UNITED STATES
NUCLEAR REGULATORY COMMISSION
WASHINGTON, D. C. 20555

March 28, 1980

Docket No. 50-206

RE: ENVIRONMENTAL QUALIFICATION OF ELECTRICAL EQUIPMENT

FIGURE 1

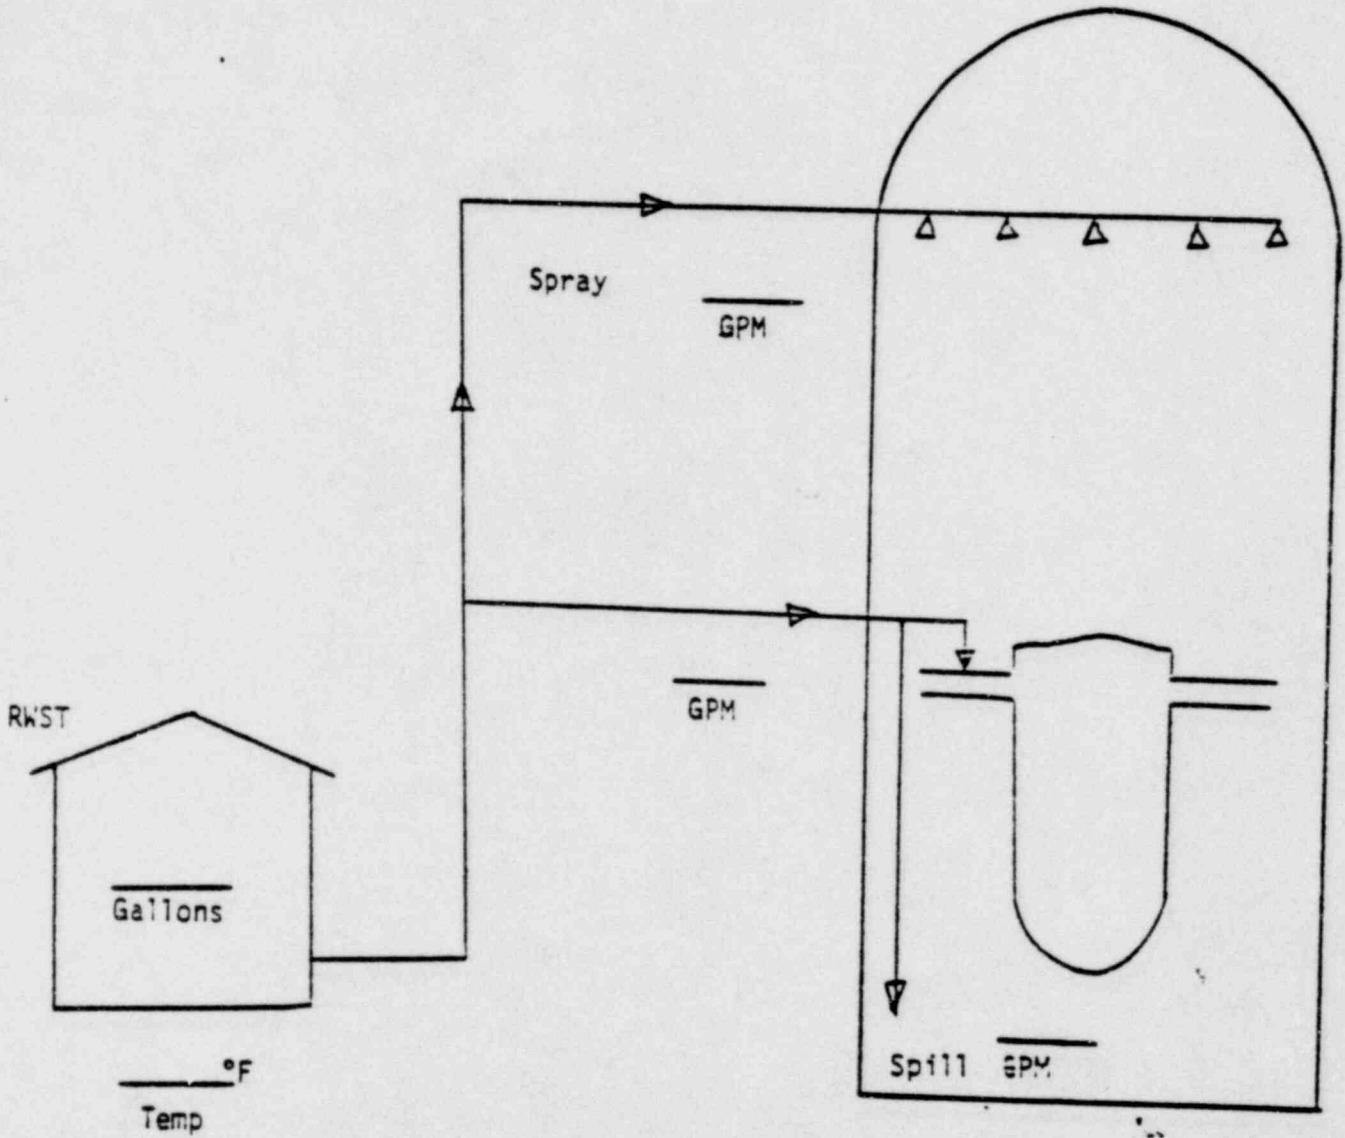
II. Figure 1 and 2 represent typical ECCS and spray systems relied on to mitigate the consequences of a pipe break. Provide the information indicated in the figures; if the plant specific systems differ from the attached figures, revise the drawings to represent your facility and provide the appropriate information.

When providing system parameters, indicate whether the values given assume a single failure and specify the single failure assumption.

FIGURE 1 - INJECTION PHASE

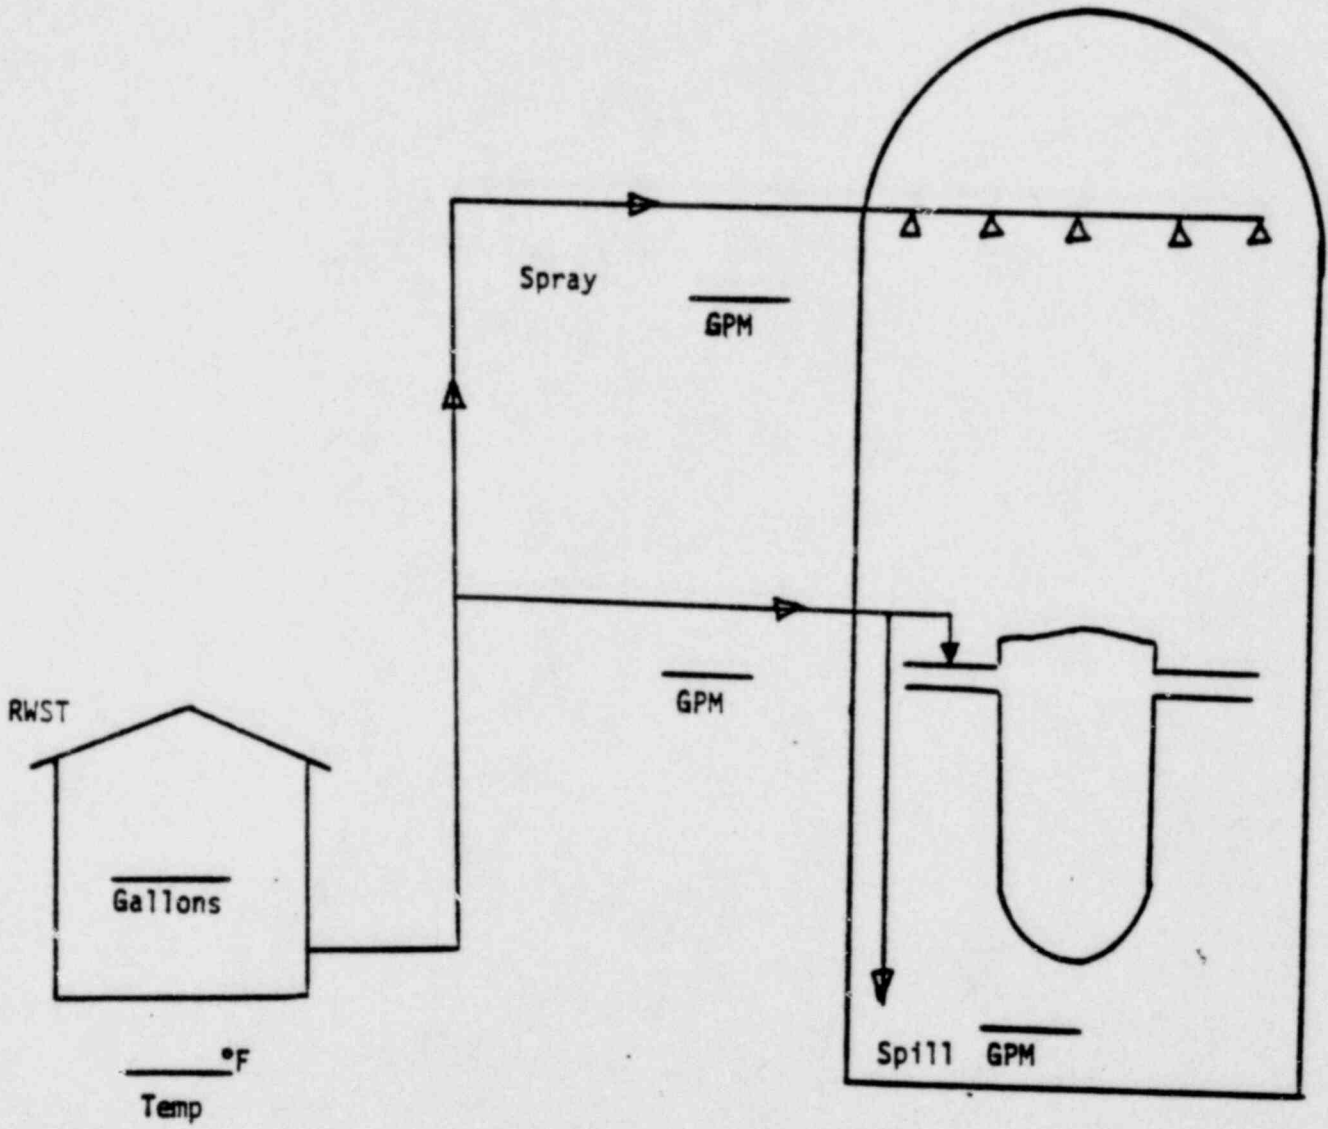
When providing system parameters, indicate whether the values given assume a single failure and specify the single failure assumption.

Figures 1 and 2 represent typical ECCS and spray systems relied on to mitigate the consequences of a pipe break. Provide the information indicated in the figures, if the plant specific systems differ from the attached figures, revise the drawings to represent your facility and provide the appropriate information.
